Title - Sujet Warehouse Racking Rayonnage d'entrepôt	
Solicitation No. - N° de l'invitation W0107-22MB03/A	Amendment No. - N° modif. 002
Client Reference No. - N° de référence du client W0107-22-MB03	Date 2021-08-25
GETS Reference No. - N° de référence de SEAG PW-\$PET-907-1687	
File No. - N° de dossier PET-1-55006 (907)	CCC No./N° CCC - FMS No./N° VME
Solicitation Closes - L'invitation prend fin at - à 02:00 PM Eastern Daylight Saving Time EDT on - le 2021-08-30 Heure Avancée de l'Est HAE	
F.O.B. - F.A.B. Plant-Usine: <input type="checkbox"/> Destination: <input checked="" type="checkbox"/> Other-Autre: <input type="checkbox"/>	
Address Enquiries to: - Adresser toutes questions à: Lamorie, Cindy	Buyer Id - Id de l'acheteur pet907
Telephone No. - N° de téléphone (613) 401-3643 ()	FAX No. - N° de FAX () -
Destination - of Goods, Services, and Construction: Destination - des biens, services et construction: Repair Parts Stores Section (RPSS) 257 Montgomery Rd, Bldg H-112 Garrison Petawawa, ON

AMENDMENT 002

WAREHOUSE RACKING

This amendment to this Request for Proposal is raised to answer questions:

Building floor plan H-112

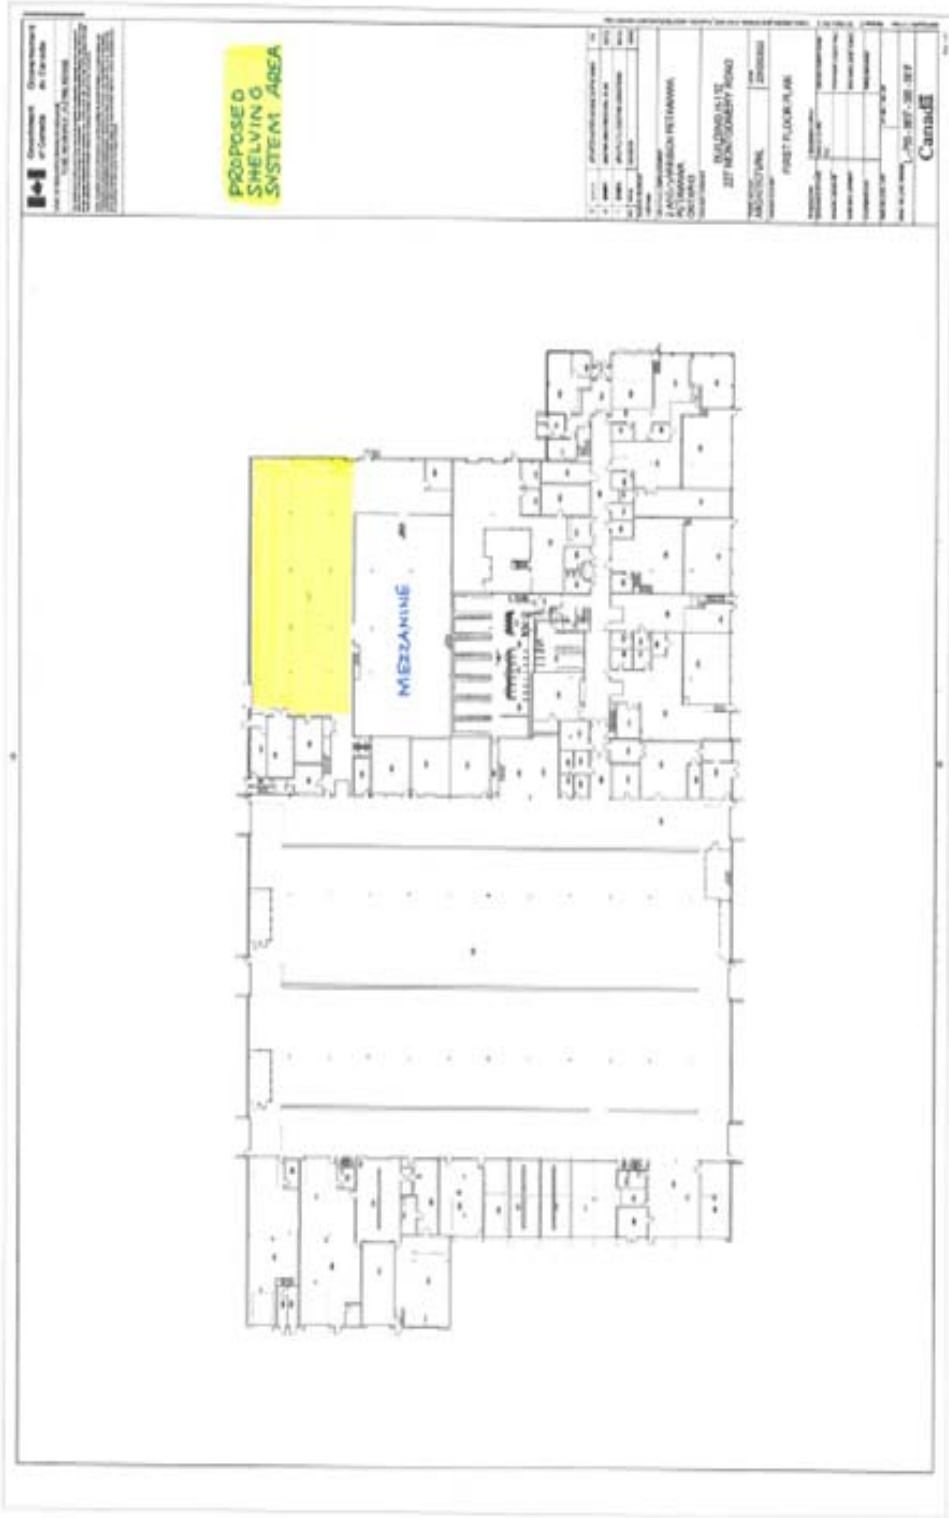
Can building drawings be provided?

See Annex A below
